Final Value Planning Report

Riverside Revitalization Sewage Treatment Plant and Collection System

Date: November 2, 2021 (revised February 7, 2022)
Our Ref: 30065414
Subject: Final Value Planning Report

PROVIDE INJECTION GALLERY IN LIEU OF CONSTRUCTED WETLANDS

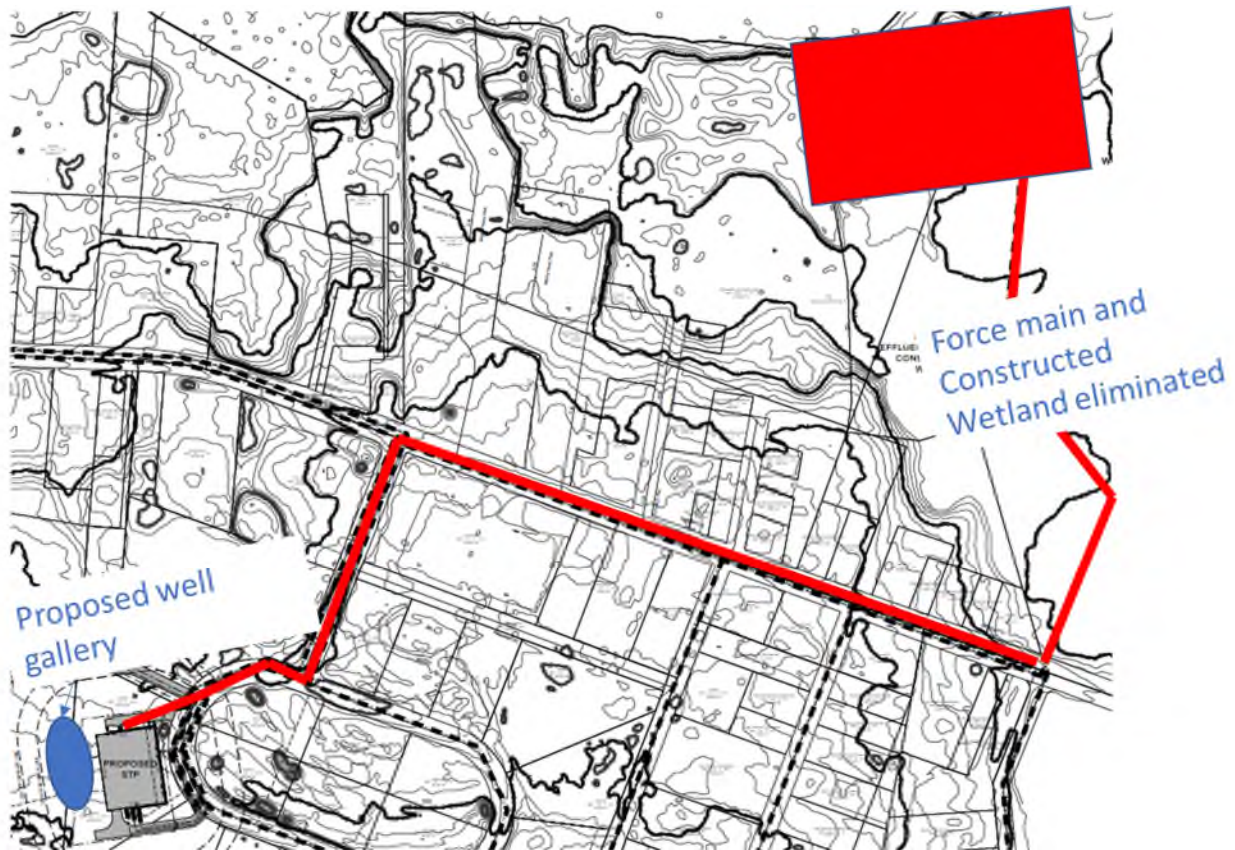
- Description of Baseline Concept:** The design documents state that treated flow from the sewage treatment plant will be conveyed and discharged into constructed wetlands. The proposed constructed wetland footprint is approximately 3.5 acres and located along the Peconic River on undeveloped parcels historically used for dredge spoils. Treated effluent will be conveyed to the constructed wetland via a force main.
- Description of Alternative Concept:** Eliminate the need for a constructed wetland by discharging treated water via injection gallery behind the current STP plant building (or over a few locations).

| VE Proposal | | Decision | Reason for acceptance or rejection (Or use the pages at the end of this form) | Design Decision Review | Functional Benefit* | | | | | VE Team Estimated Savings or Cost Avoidance (-) or Cost Added (+) | Actual Estimated Savings or Cost Avoidance (-) or Cost Added (+) |
|-------------|--|---|--|-----------------------------|---------------------|------------|-------------|--------------|-------|---|--|
| CW-1 | Provide Injection Gallery In lieu of Constructed Wetlands | F | Cost assumptions must be verified. Need to ensure meeting CPB discharge requirements (2.5 mg/l max) – leading to a hardship waiver/exemption (| | X | X | X | X | | -\$918,000 | |

Figure 2 – FEMA Flood Map

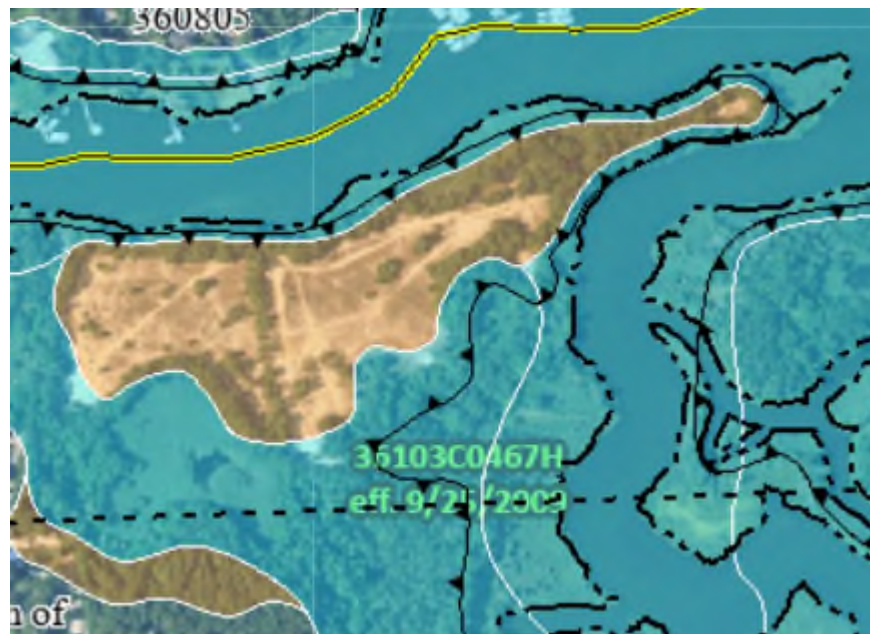
The design documents state that community would be brought on line to the proposed treatment plant in phases, and because of this the flow regime of the constructed wetland would increase over time. As such, the constructed wetland should be designed to dynamically adapt to different flow characteristics. A potential suggestion would be incorporating micro topography within the constructed wetland cell to allow for an initial mosaic of habitats transitioning to one habitat type as water increases within the cell.

Figure 1 – Treatment Plant Layout

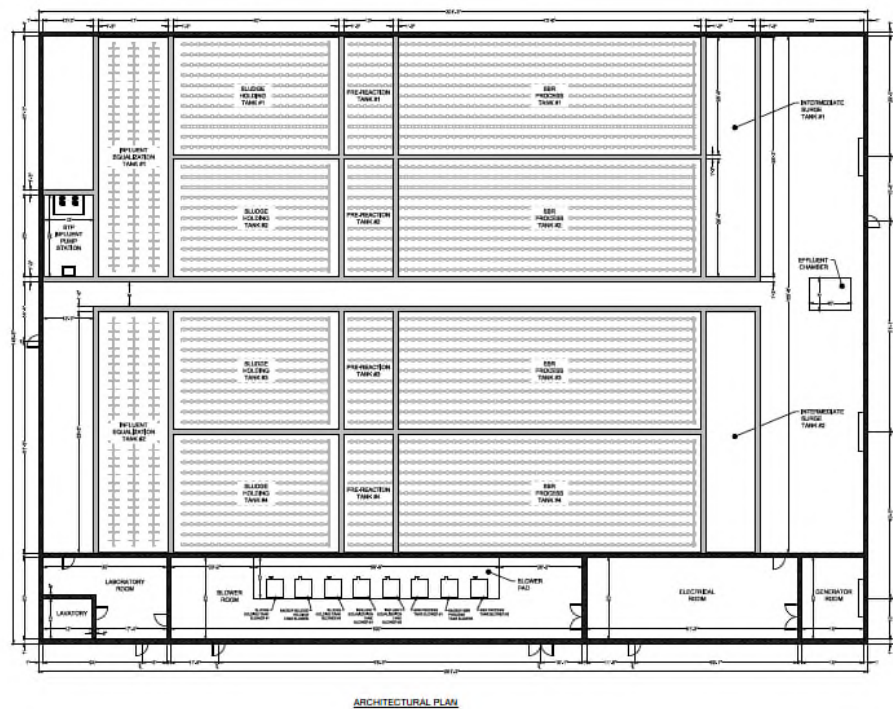
- 6. Treatment facility layout optimization:** 2018 report provides a preliminary architectural plan of the STP building which includes raw influent pumping, influent screening, flow equalization, activated sludge (SBR), aerated sludge storage, and effluent pumping (see image below – Figure 1).

6. Treatment facility layout optimization: The 2018 report provided does not include certain items identified above. The treatment facility layout should be revised to allocate space for these items should they become necessary.

Existing Conditions Sludge Treatment Process Flow Diagram

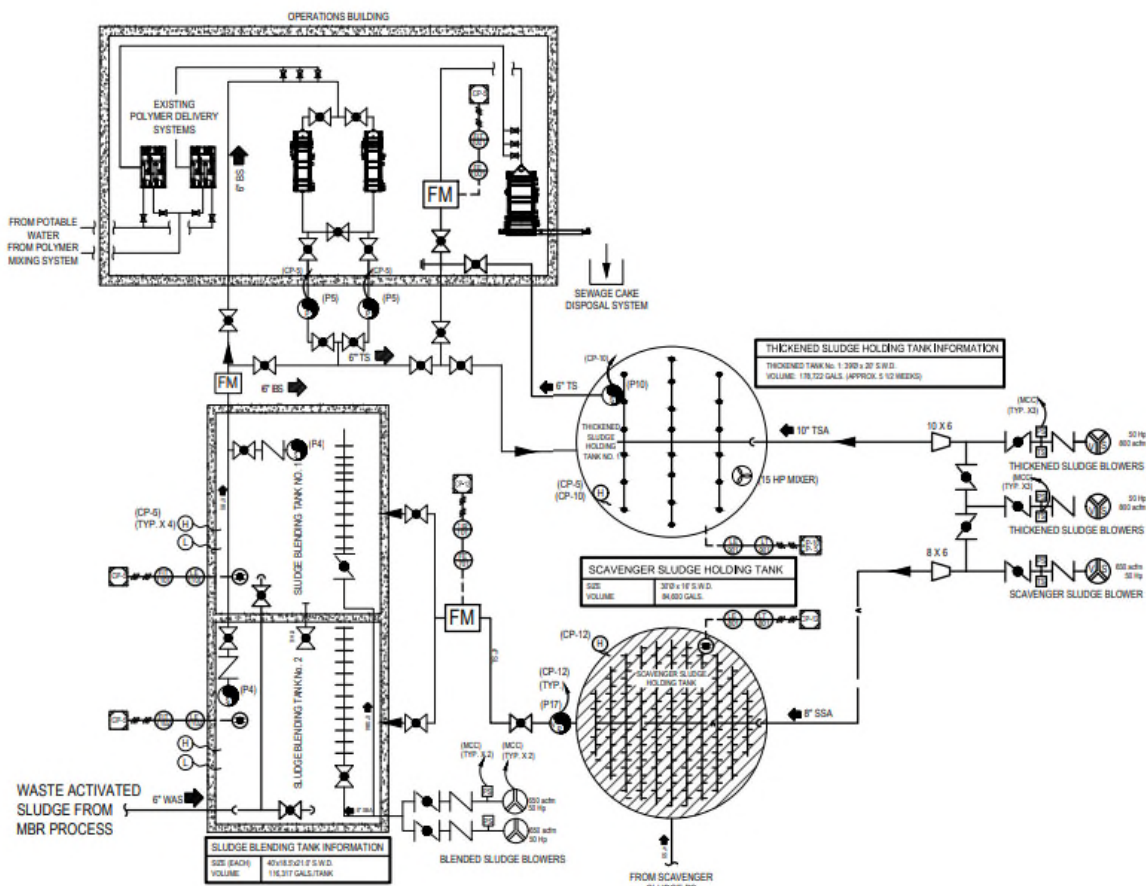
- Description of Baseline Concept:** Based upon discussions with the engineering team and the Town, sludge produced at the new Riverside STP will be hauled to the nearby Riverhead WRRF and introduced at a) either the headworks of the liquid treatment train or b) the dedicated scavenger waste treatment system for further processing. It has been confirmed that the latter is proposed and below is the existing sludge treatment flow diagram at Riverhead.

- Description of Alternative Concept:** It is recommended that the Town and the engineering design team review and vet sludge production estimates and confirm with the Riverhead WRRF that this solids loading can be accommodated at their facility. In addition, the Town and the engineering design team should ascertain if a thermal sludge dryer will be added to the solids treatment process at the Riverhead WRRF, which may allow for synergy between the two facilities in terms of

| VE Proposal | | Decision | Reason for acceptance or rejection (Or use the pages at the end of this form) | Design Decision Review | Functional Benefit* | | | | | VE Team Estimated Savings or Cost Avoidance (-) or Cost Added (+) | Actual Estimated Savings or Cost Avoidance (-) or Cost Added (+) |
|-------------|--|---|--|-----------------------------|---------------------|------------|-------------|--------------|-------|---|--|
| TP-7 | Expand and confirm biosolids management at Riverhead WRRF | F | Will discuss with Riverhead. A politics and agreement issue (IMA). Key issue is volume and processing. RH plans to accept outside waste. | | X | X | | X | | Design Suggestion | |

EXPANSION OF RIVERHEAD WRRF AND RIVERSIDE FLOW DIVERSION

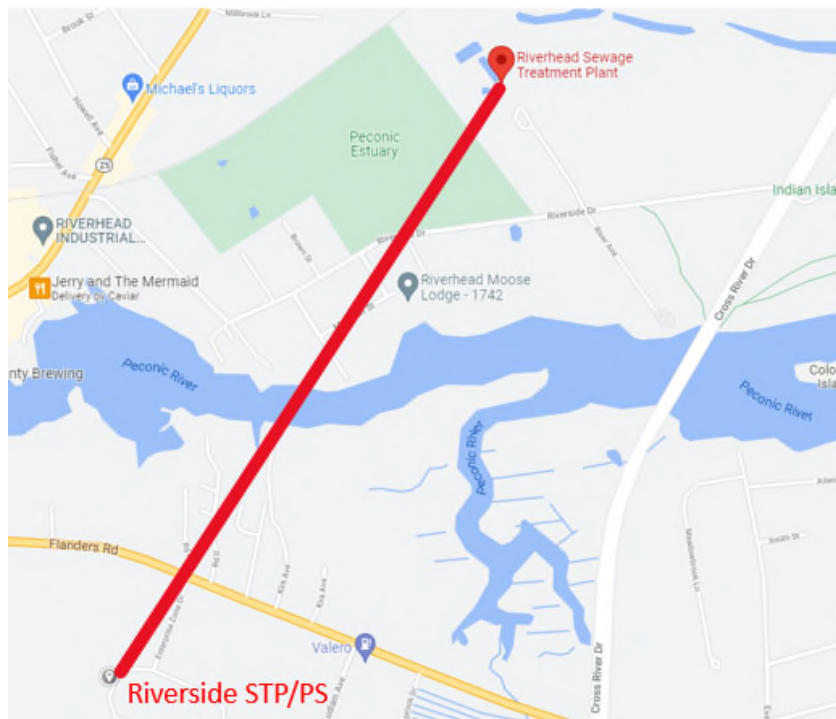
- 1. Description of Baseline Concept:** The project currently includes wastewater collection/conveyance and a new centralized STP sized to treat up to 0.8 MGD, and a constructed wetland for discharge of treated wastewater within the hamlet of Riverside.
- 2. Description of Alternative Concept:** Provide for treatment capacity expansion at the Riverhead WRRF, bringing the permitted capacity from 1.5 MGD up to approximately 2.3 MGD. Collect and convey the wastewater from Riverside to a new transfer pump station to direct the flow via force main to the Riverhead WRRF. Image below shows proximity of potential Riverside STP or Transfer PS to the Riverhead WRRF (approximately less than 1.0 miles between the two facilities).

5. **Discussion:** This alternative would include wastewater collection and conveyance to a central flow transfer pump station located within the Riverside community which would then direct the flow via force main to the Riverhead WRRF (either under the Peconic River or traverse under the Cross River Drive bridge). The Riverhead WRRF would require an upgrade/expansion and permit modification to accept the additional wastewater flow. This approach may provide the Town of Southampton with numerous benefits as detailed above but would link economic growth with decisions made by additional stakeholders.

REMOVE GENERATOR ROOM FROM NEW TREATMENT PLANT BUILDING AND PLACE OUTSIDE OF THE BUILDING AND REPURPOSE SPACE

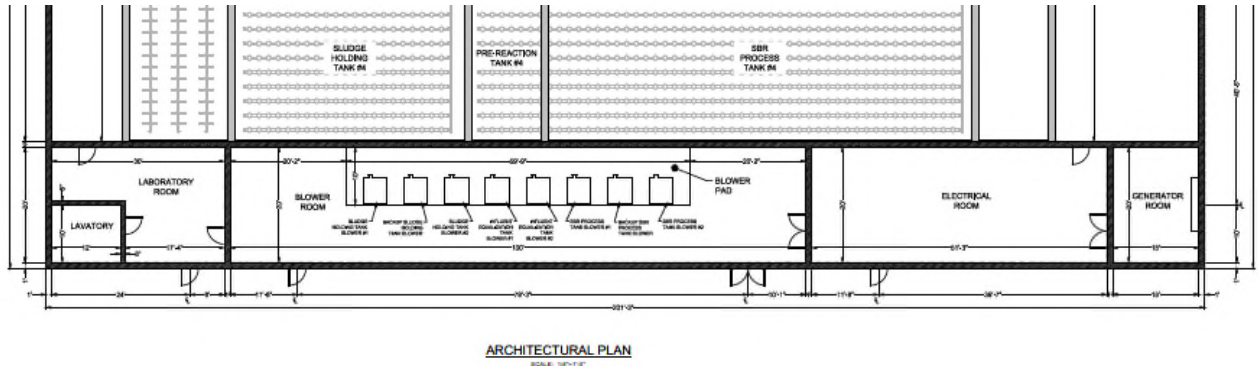
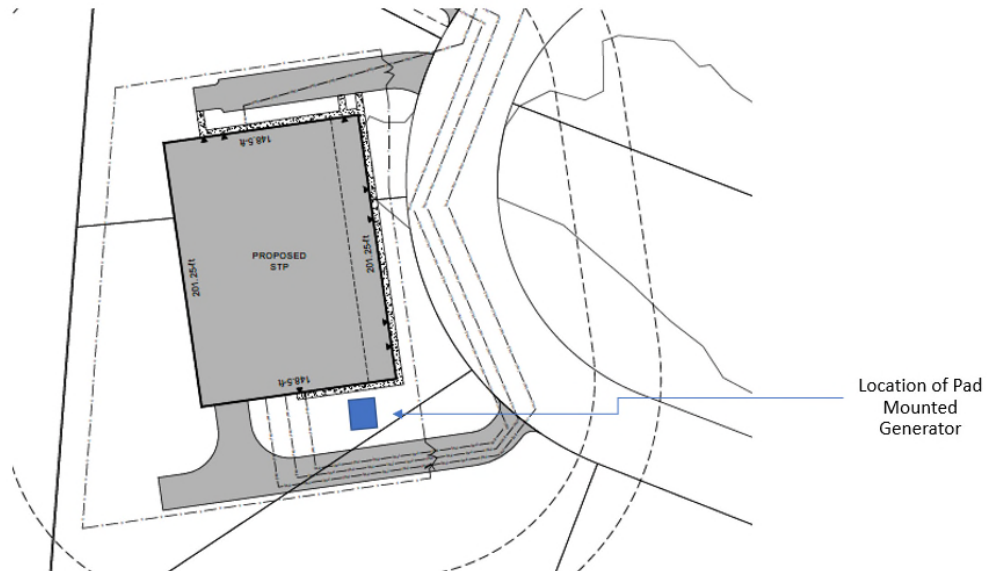
1. Description of Baseline Concept: The engineering report indicates that the southern extents of the treatment building incorporates a lavatory, a laboratory, a blower room, an electrical room, and a generator room as shown below:

2. Description of Alternative Concept: Proposal targets a modification to the non-process space that relocates the generator outside of the building and utilizes that space in the building to either expand the laboratory room or the electrical room. Proposed location of generator is moved to the south side of the plant which would require swapping the location of the electrical room and the laboratory and lavatory.

| VE Proposal | | Decision | Reason for acceptance or rejection (Or use the pages at the end of this form) | Design Decision Review | Functional Benefit* | | | | | VE Team Estimated Savings or Cost Avoidance (-) or Cost Added (+) | Actual Estimated Savings or Cost Avoidance (-) or Cost Added (+) |
|-------------|--|---|--|-----------------------------|---------------------|------------|-------------|--------------|-------|---|--|
| TP-11 | Remove generator room from new treatment plant building and place outside of the building and repurpose space | A | Design modification- engineer will confirm | | X | X | | X | | Design Suggestion | |

Figure 2 - Alternative Pumping Station Locations (in Orange)

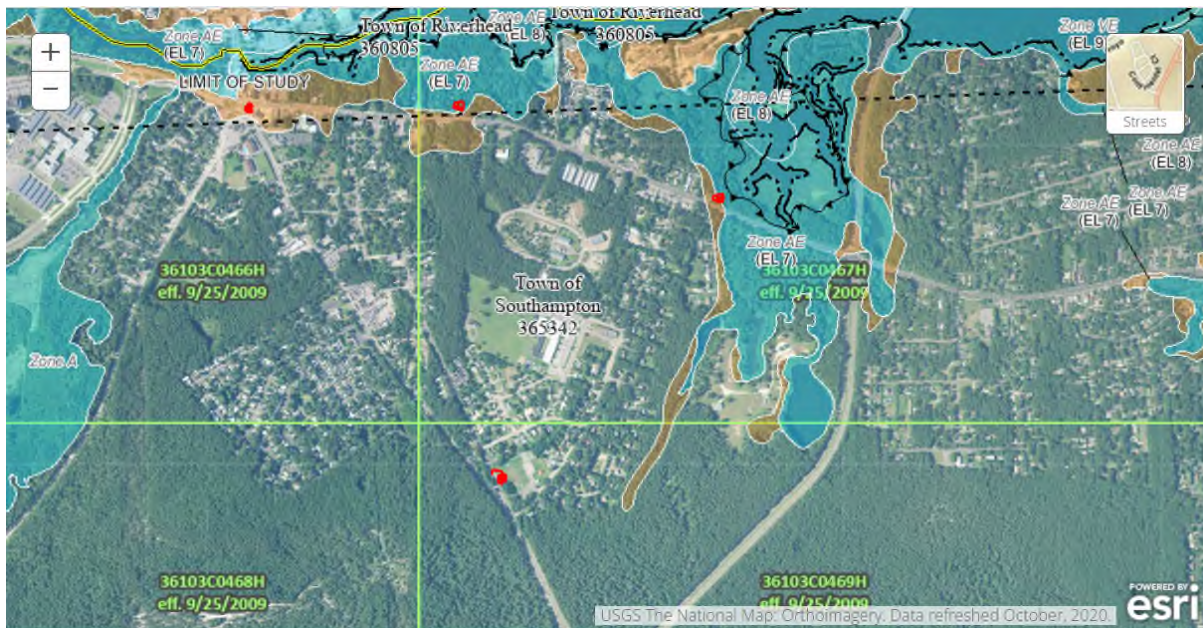
- Description of Baseline Concept:** The conceptual design documents show four pumping stations within the proposed collection system. However, as shown the collection system sewers and pumping stations would need to be quite deep, and there are several low-lying areas that would not be able to be served by gravity collection for conveyance. Residences and businesses in these low-lying areas would need to pump their service connection to the sewer district.

The three proposed northern pump stations are within or close to the 100-year flood zone.

PROVIDE GRAVITY SEWER NEAR STP IN LIEU OF FORCE MAINS TO INFLUENT STP PUMP STATION

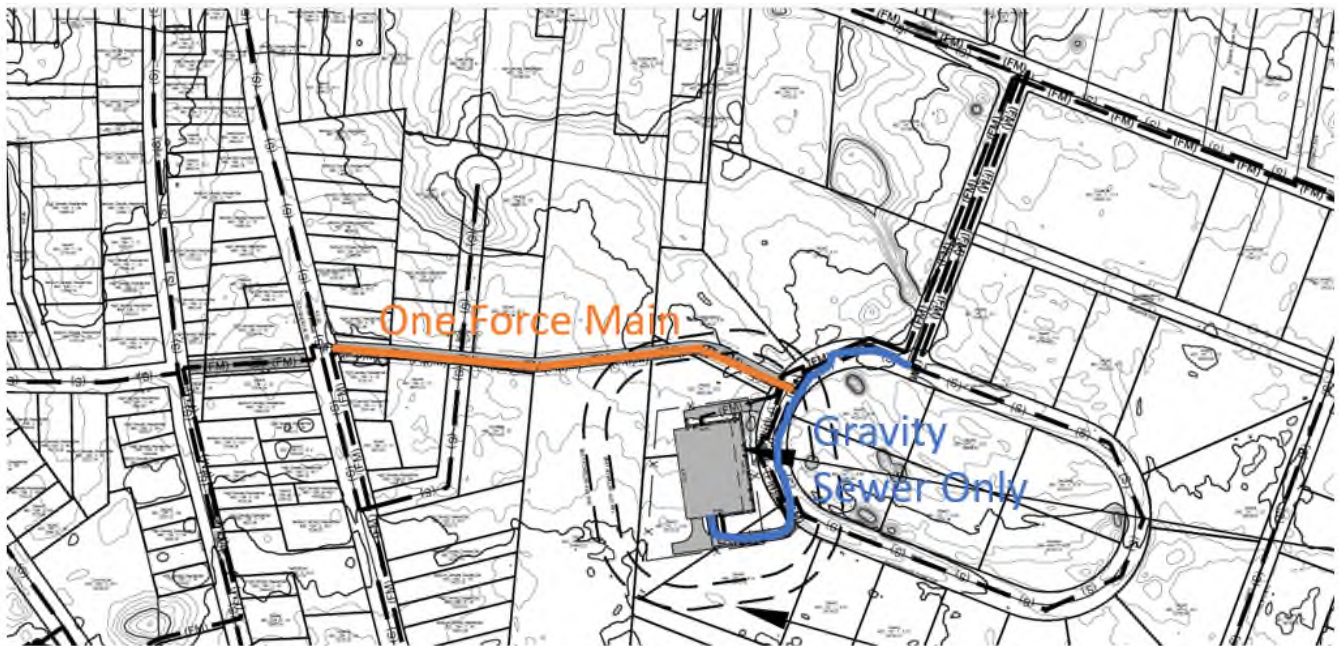
- 1. Description of Baseline Concept:** The conceptual design documents show two force mains running in parallel as they approach the STP from the West, and another force main approaching the STP from the North. All three force mains wrap around the East side of the STP before entering the influent lift station on the south side of the STP

| VE Proposal | | Decision | Reason for acceptance or rejection (Or use the pages at the end of this form) | Design Decision Review | Functional Benefit* | | | | | VE Team Estimated Savings or Cost Avoidance (-) or Cost Added (+) | Actual Estimated Savings or Cost Avoidance (-) or Cost Added (+) |
|-------------|--|---|---|-----------------------------|---------------------|------------|-------------|--------------|-------------------|---|--|
| CS-2 | Provide gravity sewer near STP in lieu of force mains to influent STP pump station | F | Engineer will confirm – may be beneficial (can be open to combined FMs – add a sewer interceptor (trade-off deeper design potentially)) | | | | X | | Design Suggestion | | |
